ROAD, WATER,
AND SANITARY
SEWER PROFILES

APPLEWOOD, SECTION No. 19

"THE ORCHARDS"
PREPARED FOR

SHEET 8 OF 13

INTERSECTION DETAIL
SCALE: 1" = 20'

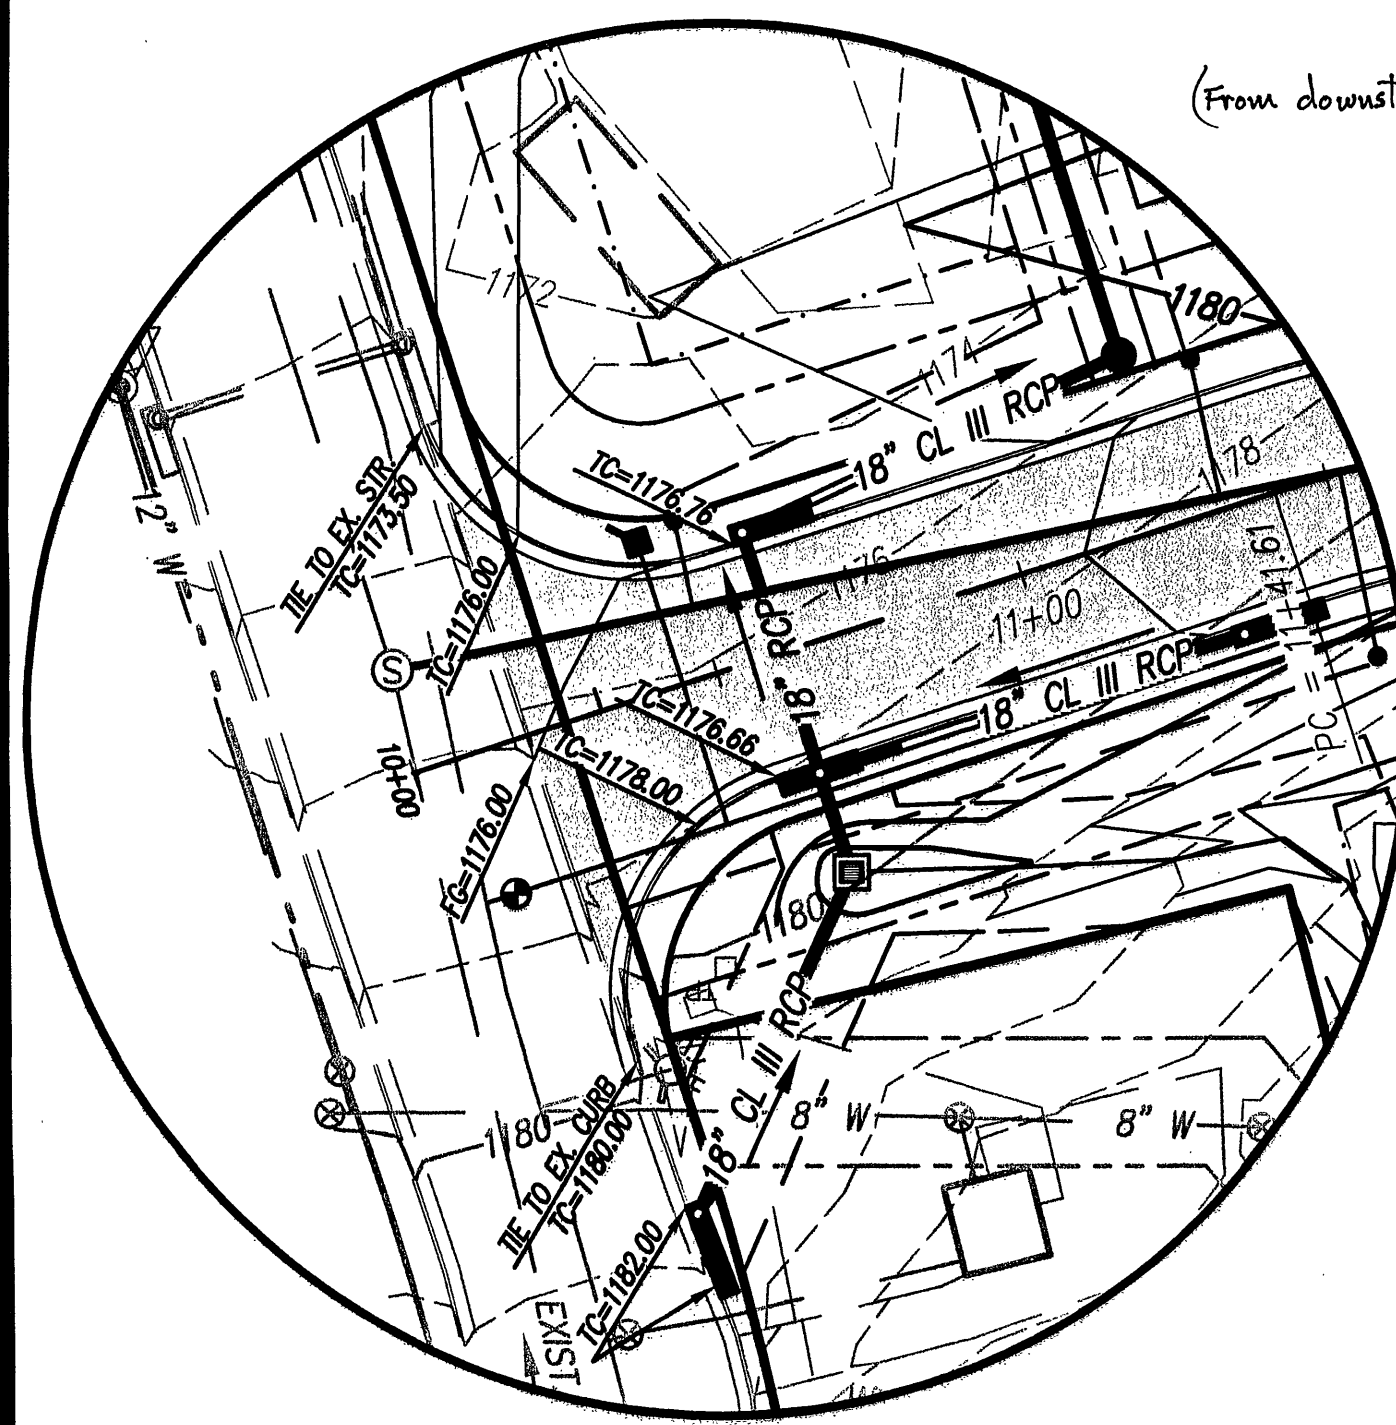
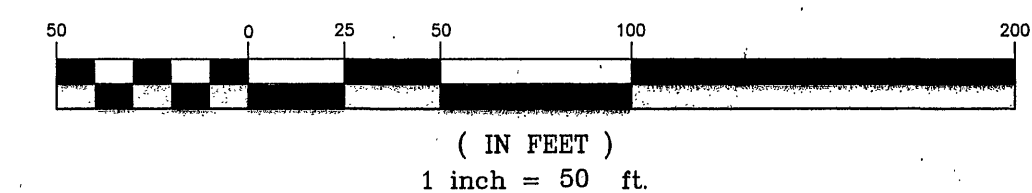
Fire Hydrant
To Valve 41'
Air Release To Valve 4'

D.I. South
115'
D.I. North 110' 8" H₂O valve

As-Built 2.27.09 K.Winslow
